A303 Sparkford to Ilchester Dualling Scheme

Environmental Statement Table of Errata

Regulation Number:	
Planning Inspectorate Scheme	TR010036
Reference	
Application Document Reference	9.2
Author:	A303 Sparkford to Ilchester Dualling Scheme Project Team, Highways England

Appendix B Figure 1.1 - Noise survey positions (western section of scheme extents)

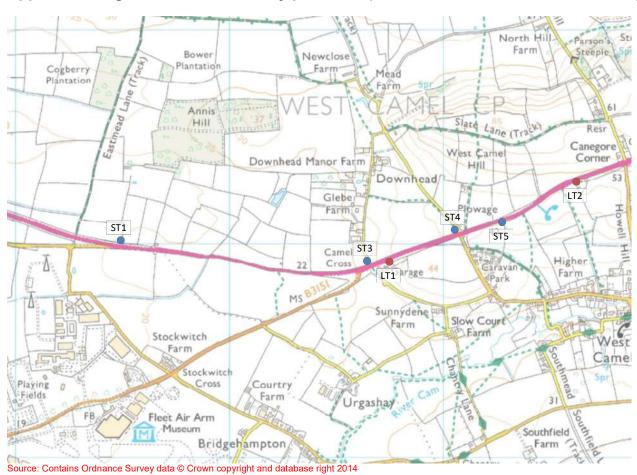
1.4.10	Volume 6.3 Environmental Statement Appendix 11.1 Baseline Noise Survey Results (APP- 090)	1	The Short Term and Long Term noise survey locations are not numbered on Figure 1.1 in Appendix 11.1 Baseline Noise Survey Results (APP-090). For clarity, can the Applicant provide a plan showing clearly labelled noise monitoring locations?	Amended in response to ExA question 1.4.10. Typographical error in Figure 1.1.	Figure 1.1 of Environmental Statement Appendix 11.1 Baseline Noise Survey Results (APP-090) is amended and can be found in appendix B of this document.
